Redundant Brake Pedal Micro Switch, Removal VN VHD

SP 432-024, Redundant Brake Pedal Micro Switch, Removal

(June 2008)

W8003940

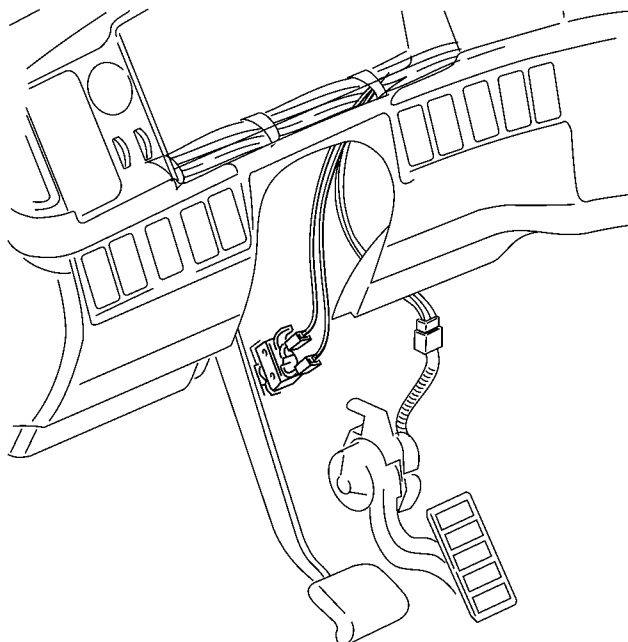
- 1 Remove the drivers side lower right hand dash panel to gain access to the brake pedal switch.

W3007823

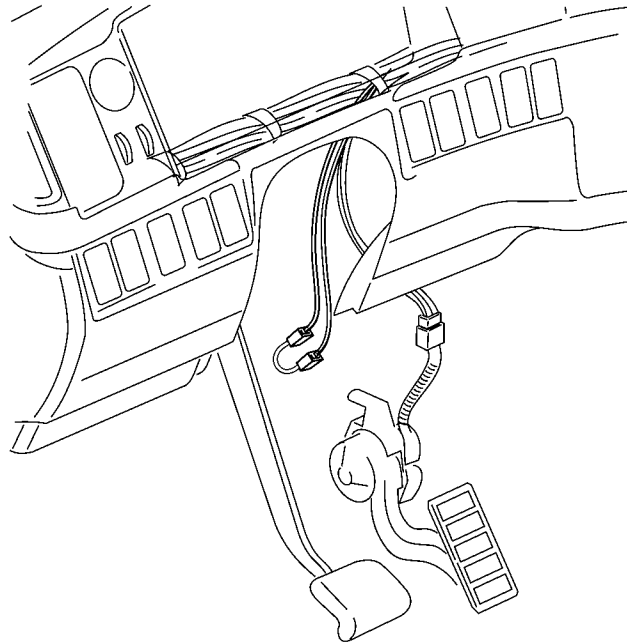
- 2 Locate and remove the I-Shift brake pedal micro switch.

W8003941

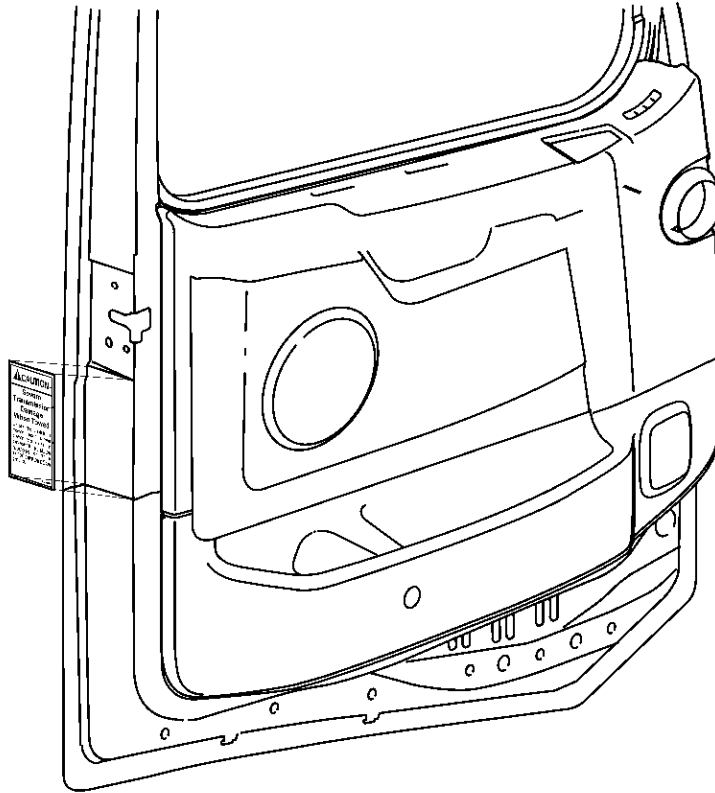
- 4 Reinstall the drivers side lower right hand dash panel.
- 5 Lower the drivers side sun visor and install the new I-Shift instruction decal over the existing decal.
